DEVELOPMENT REVIEW BOARD

Parks and Recreation Department

PR-2019-002402
SI-2021-002080 – SITE PLAN
BOWMAN CONSULTING GROUP requests the aforementioned action(s) for all or a portion of: LOT 12, UNIT 5, AVALON SUBDIVISION zoned NR-BP, located on 98TH containing approximately 1.46 acre(s). (K-9)
PROPERTY OWNERS: KEVIN MATTSON-RS BLUEWATER LLC
REQUEST: DRB SITE PLAN FOR DRIVE THRU RESTAURANT

01-05-2021

02 TREE PLANTING
NTS

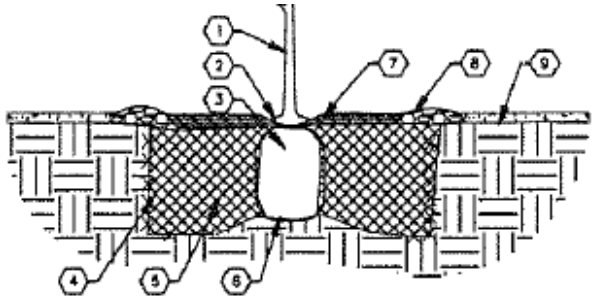
Per IDO Section 5-6(C)(5)(e)Organic mulch is required as ground cover under trees within a 5-foot radius around the tree trunk, but not directly against the trunk. In these areas, weed barrier fabric is prohibited. (please revise detail to be similar to #7 in figure.)
